**Notification subject:** ERRATA - PIC12(L)F1822/PIC16(L)F1823 Silicon Errata and Data Sheet Clarification Errata Document Revision

**Description of Change:** Adding Oscillator and EUSART Errata

## **Product Change Notification - SYST-18YBGA236**

## PIC12(L)F1822/PIC16(L)F1823 Family Silicon Errata and Data Sheet Clarification

**FIGURE 1: INSTRUCTION CYCLE DELAY CALCULATION EXAMPLE**

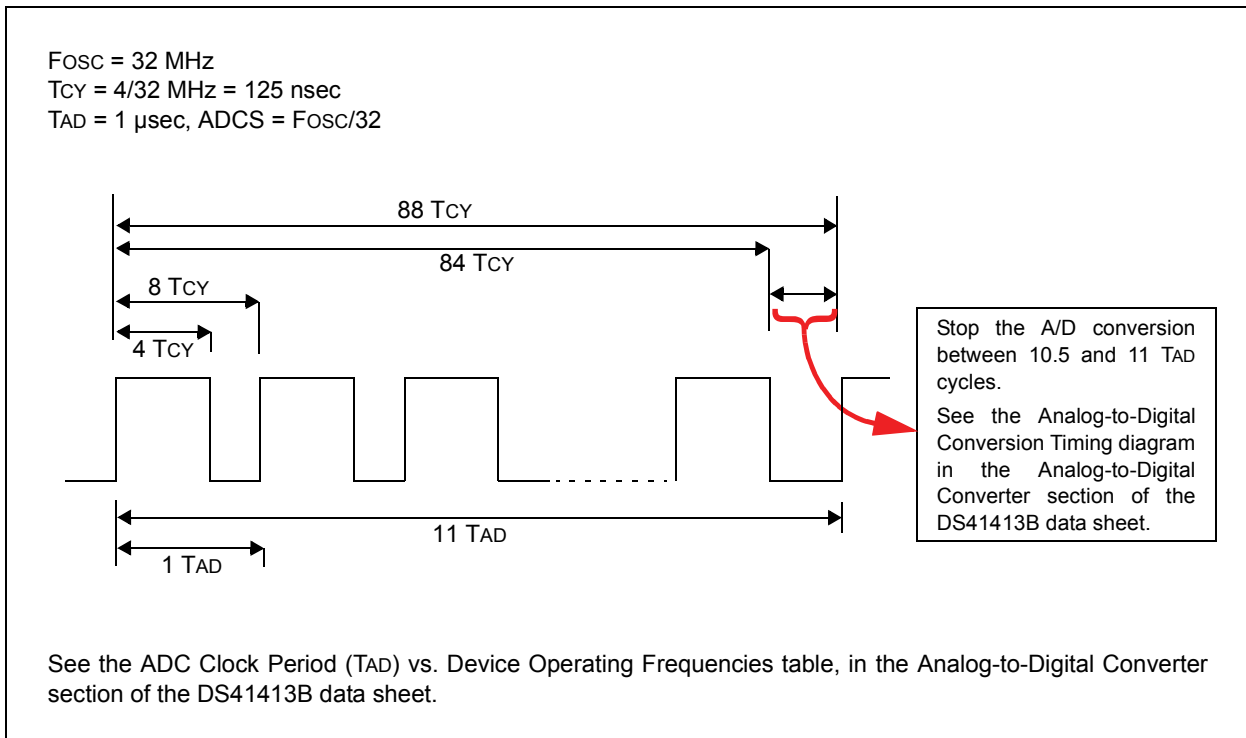
Under certain device operating conditions, the ADC conversion may not complete properly. When this occurs, the ADC Interrupt Flag (ADIF) does not get set, the GO/DONE bit does not get cleared and the conversion result does not get loaded into the ADRESH and ADRESL result registers.

Method 2: Provide a fixed delay in software to stop the A-to-D conversion manually, after all 10 bits are converted, but before the conversion would complete automatically. The conversion is stopped by clearing the GO/DONE bit in software. The GO/DONE bit must be cleared during the last 1/2 TAD cycle, before the conversion would have completed automatically. Refer to Figure 1 for details.

In Figure 1, 88 instruction cycles (TCY) will be required to complete the full conversion. Each TAD cycle consists of 8 TCY periods. A fixed delay is provided to stop the A/D conversion after 86 instruction cycles and terminate the conversion at the correct time as shown in the figure above.

**Note:** The exact delay time will depend on the choice of FOSC and the TAD divisor (ADCS) selection. The TCY counts shown in the timing diagram above apply to this example only. Refer to Table 3 for the required delay counts for other configurations.
